August 8, 2014
BOARD OF COUNTY COMMISSIONERS
ORANGE COUNTY, FLORIDA
Y14-7007 MM / ADDENDUM #1
ORANGE COUNTY CONVENTION CENTER WEST BUILDING WESTWOOD LOBBY
ENTRANCE LED SIGNS

The attached Sheet AG103 from the OCCC Westwood Lobby LED Digital Display Design Intent Bid Documents has been revised and replaced.

Orange County Convention Center
Westwood Lobby LED Digital Display
Design Intent Bid Document

Description:
Westwood Lobby LED Digital Display
MOUNTING

Westwood Lobby LED Digital Display - MOUNTING

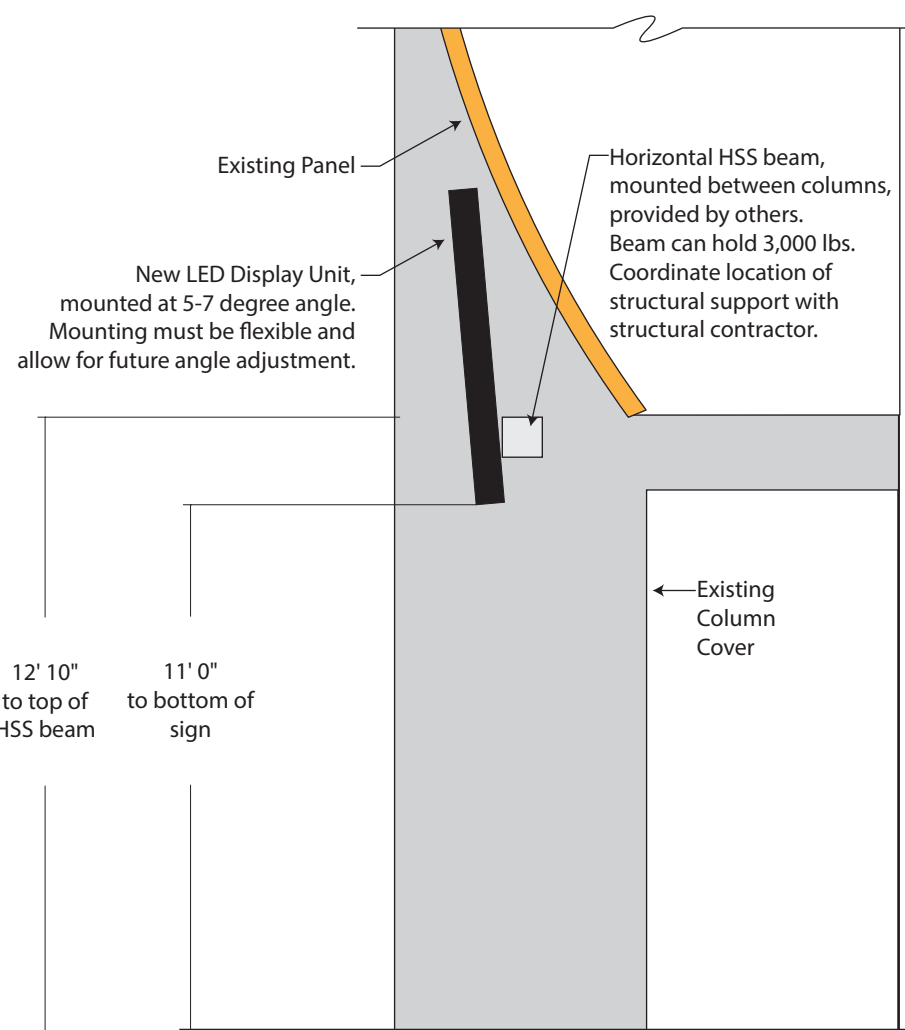
The drawing above is provided for conceptual purposes only. The contractor is responsible for engineering of the structural frame required for mounting the LED Display Units to the horizontal support beam provided by others. New LED Display Units shall be mounted at a 5-7 degree angle. Mounting must be flexible and allow for future angle adjustment. Coordination with the structural engineer and structural contractor is required prior to beginning work.

The contractor shall be responsible to make power connections which will be provided within 10' of the sign location. All cables and wiring shall be concealed from view and securely fastened but also easily accessible for future maintenance.

The contractor shall be responsible for providing the data connection, including cables and AV extenders as required, from the SureVue D6 Digital Media Player (provided and installed by the owner) to the LED displays. The owner will provide 1" conduit for the cables.

The mounting height of each LED Display Unit is 11'-0" AFF. Coordinate mounting requirements with the structural contractor.
